QUAD CITIES NUCLEAR POWER STATION UNIT 1

AMENDMENT TO FACILITY OPERATING LICENSE

Amendment No. 61
License No. DPR-29

ATTACHMENT TO LICENSE AMENDMENT NO. 61

MAXIMUM AVERAGE PLANAR LINEAR HEAT GENERATION RATE (MAPLHGR) (KW/FT)

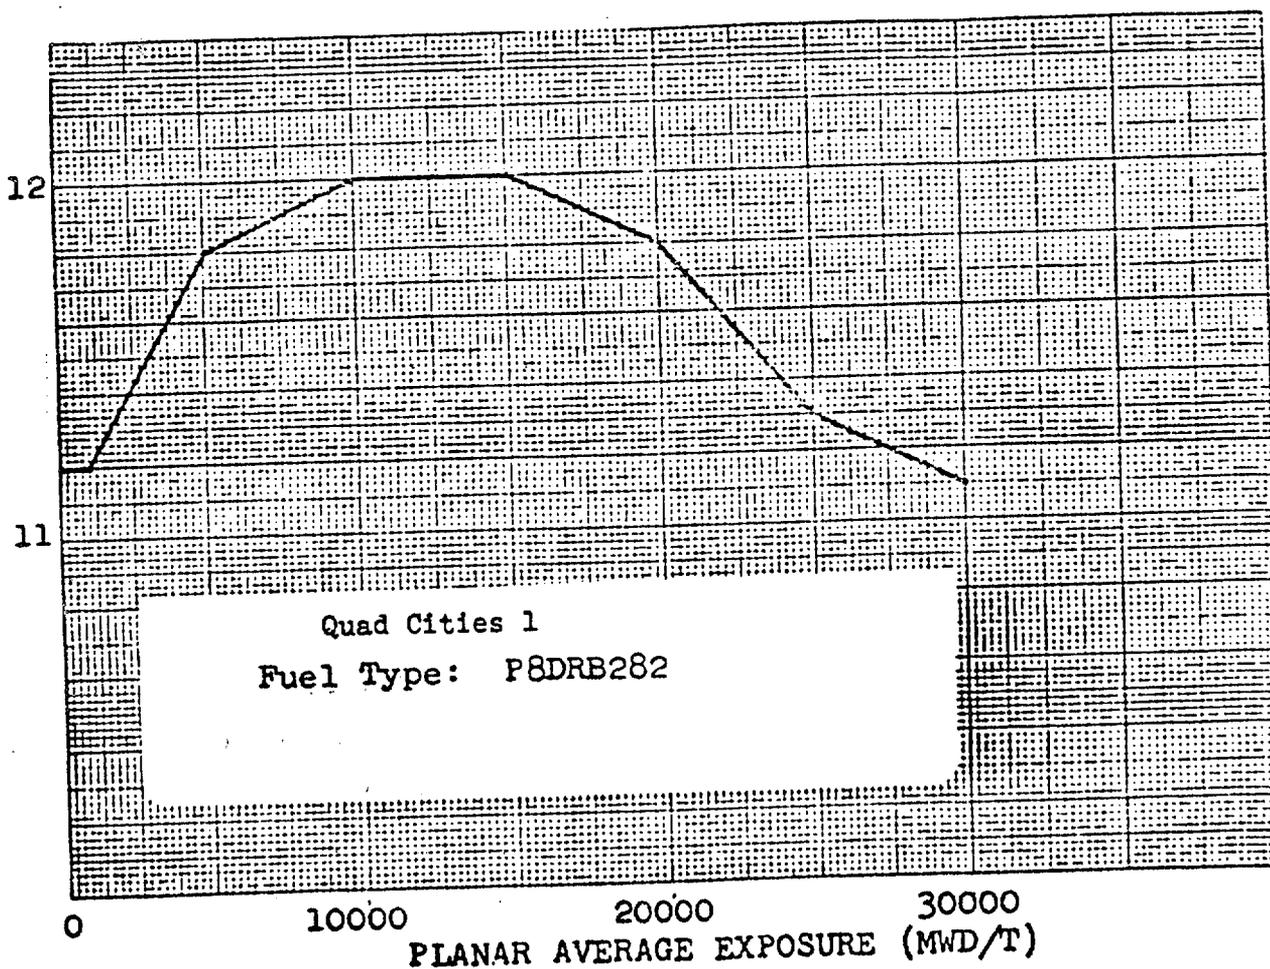
2. Page 1.1/2.1-2a is added.
3. Figure 2.1-2 is deleted.
4. Figure 3.5-1 is being replaced by 6 pages.

Maximum Average Planar Linear Heat Generation Rate (MAPLHGR)
